D. C. COOK - UNIT 1

PROPOSED REVISED  
TECHNICAL SPECIFICATION PAGES

**DONALD C. COOK  
NUCLEAR PLANT  
EXCLUSION AREA  
FIG. 5.1-1**

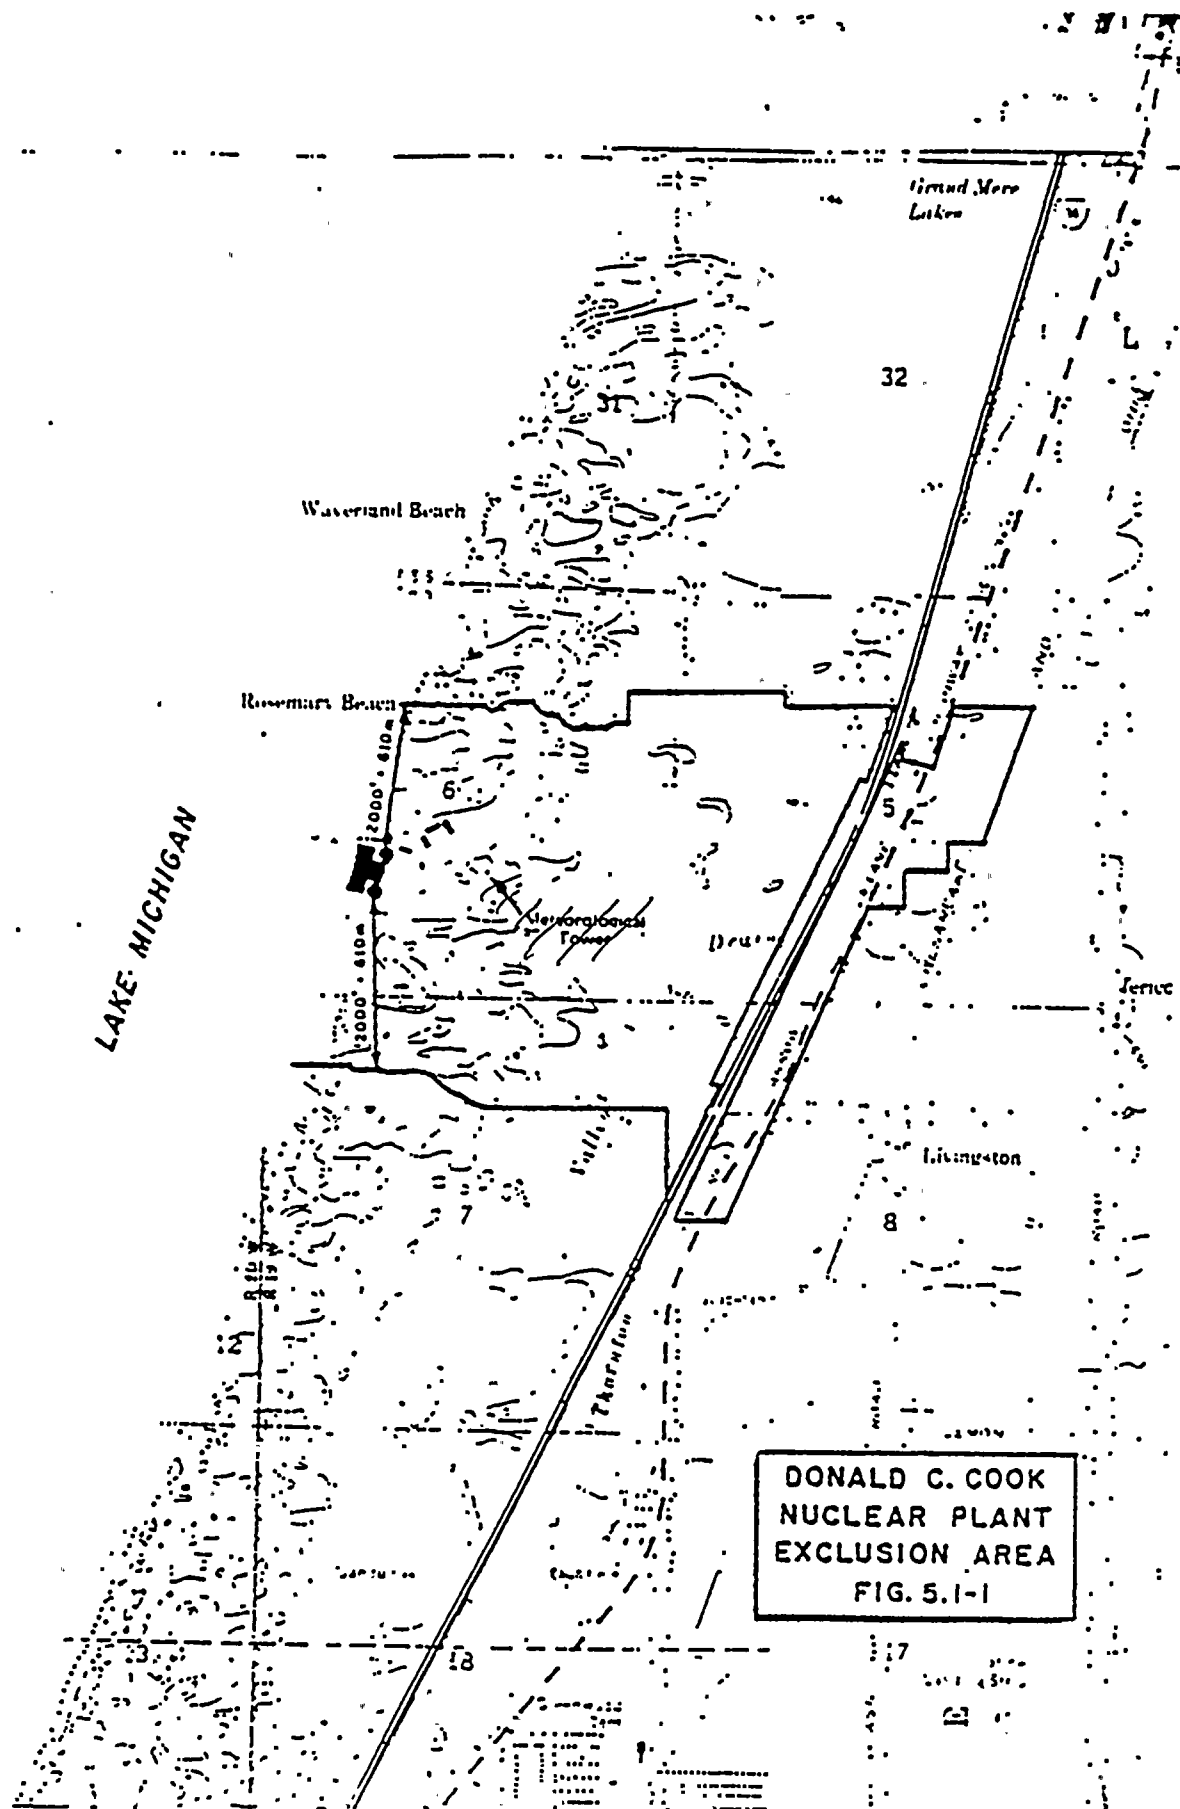
5.8.1 The meteorological tower shall be located as shown on Figure 5.1-~~2~~<sup>3</sup>.
